RE: NHTSA REFERENCE NO. 10458452
MAKE FORD
MODEL WINDSTAR
YEAR 1998
VIN 2FMZA514XB [REDACTED]
MILEAGE 84,000

Re: Ford Recall No. 01S19 --1997 and 1998 Model Year Ford Windstar Front Suspension Coil Spring Catcher

40 CFR Part 573 – DEFECT INFORMATION REPORT
01S19 – 1997 AND 1998 MODEL YEAR WINDSTAR
FRONT SUSPENSION COIL SPRINGS

SUBJECT: Safety Recall 01S19: Certain 1997 through 1998 Model Year Windstar Vehicles – Installation of Protective Spring Shields

FIGURE 1

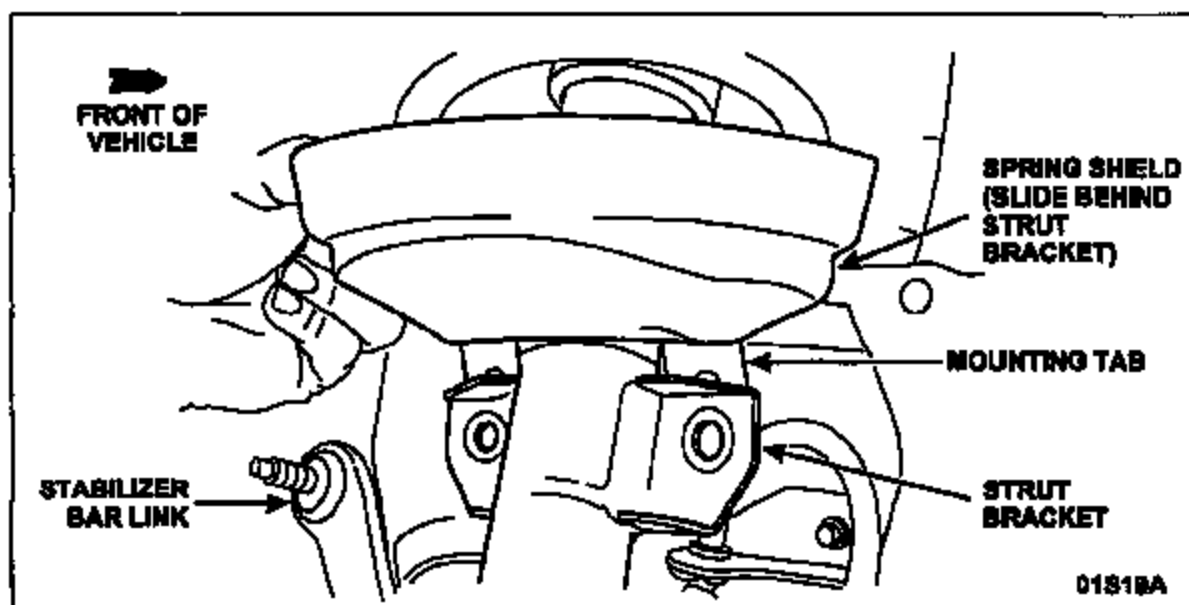
4. Position the spring shield onto the strut assembly with the mounting tab behind the strut brackets. See Figure 1.

5. Install the supplied nut and bolt, from the inside, through the spring shield mounting tab and strut bracket. Tighten the nut to 90 Nm (66 lb-ft).
6. Position the stabilizer bar link and install the supplied nut. Tighten the nut to 90 Nm (66 lb-ft).

FIGURE 2

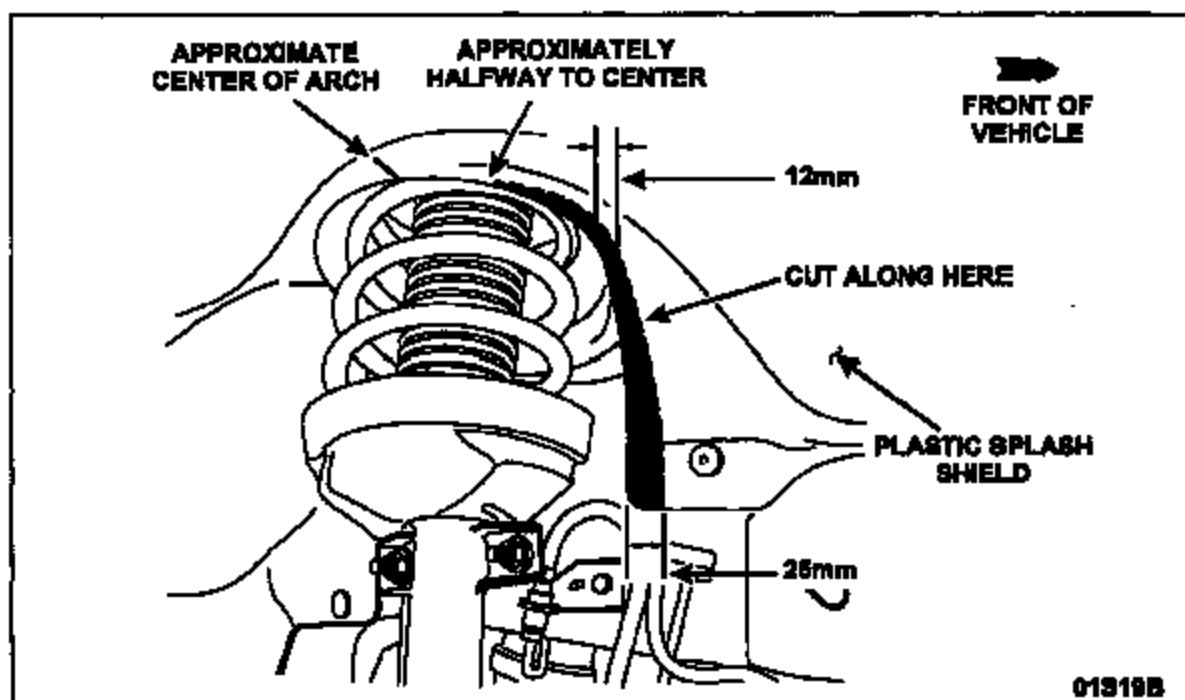
7. **NOTE:** The spring shield may contact the plastic splash shield under certain conditions. To eliminate the contact condition, the forward vertical portion of the splash shield near the strut tower must be trimmed.

Mark the forward vertical portion of the plastic splash shield as indicated in Figure 2.

- At the bottom of the affected area, place a mark approximately 25 mm (1 inch) in from the edge.
- Further up the shield, at the very beginning of the arch around the spring, place a mark approximately 12 mm (1/2 inch) in from the edge.
- Draw a line from the bottom mark, up to the top mark, then continue with a curve to about half-way to the very center of the arch.
- Using aviator snips or a similar cutting tool, cut out along the marked line.
